CONNECTION ASSESSMENT & APPROVAL PROCESS ASSESSMENT SUMMARY

**Project: Burlington TS – Installation of a New 128kV
125MVAR Capacitor Bank**

CAA ID: 2003 – EX123

Date: March 19, 2003

Figure 1 - Burlington TS 115kV Switchyard

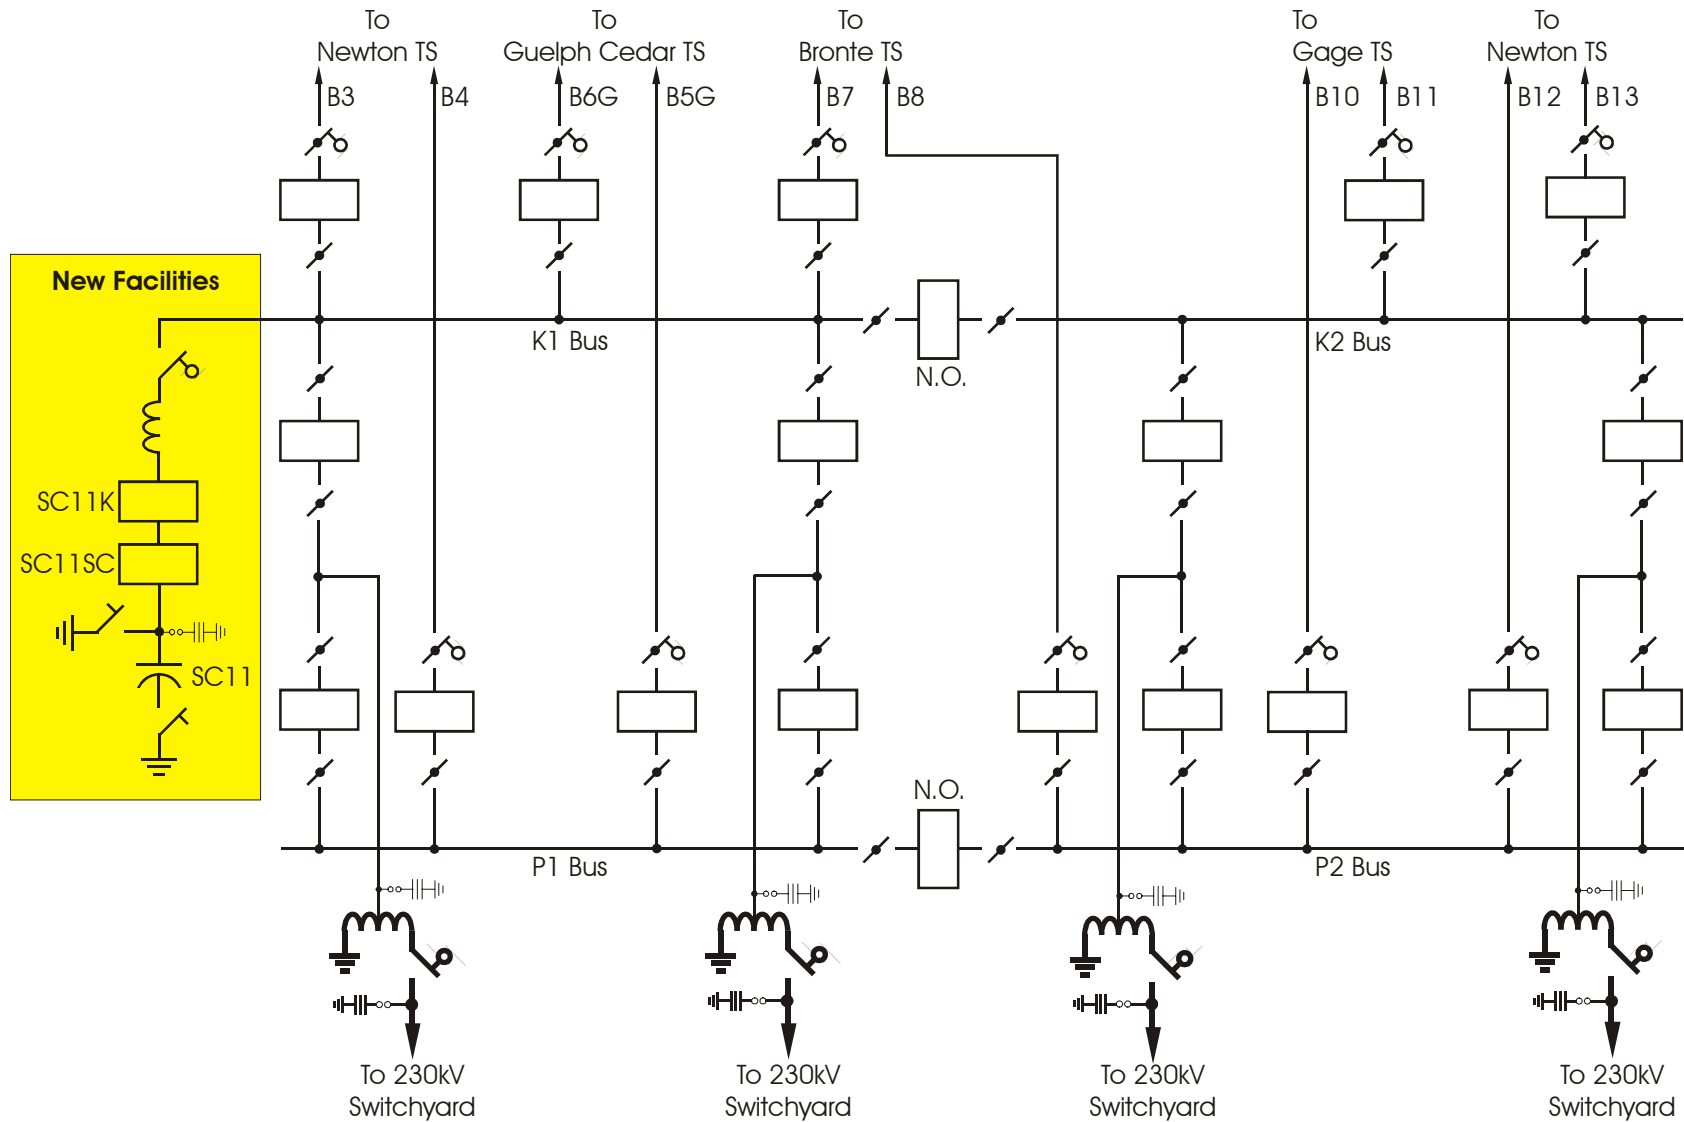
With the present fault level at the 115kV switchyard of the Burlington TS, the voltage change upon switching the new 125MVAR capacitor bank either in or out of service is expected to be less than 2%.

A power flow study has confirmed that the voltage change upon switching a 128kV 125MVAR capacitor bank at Burlington TS would be about 1.6%. This would comply with the maximum limit of 4% for capacitor switching stipulated in the Market Rules.

The two SF₆ circuit breakers have an interrupting capability of 40kA. With the proposed arrangement of having the current limiting series reactors installed upstream of the circuit breakers, the 40kA breakers would be adequate for the projected fault levels. The applicant has further specified that should physical constraints dictate that the series reactors be installed downstream of the circuit breakers, then the breakers would be rated at 63kA.

The proposed new capacitor bank at Burlington TS would improve the voltage profile in the Hamilton - Burlington area and would have no adverse impact on the IMO-controlled grid.

Based on the above assessment, it is recommended that a Notification of Approval for this proposal be issued to the applicant.
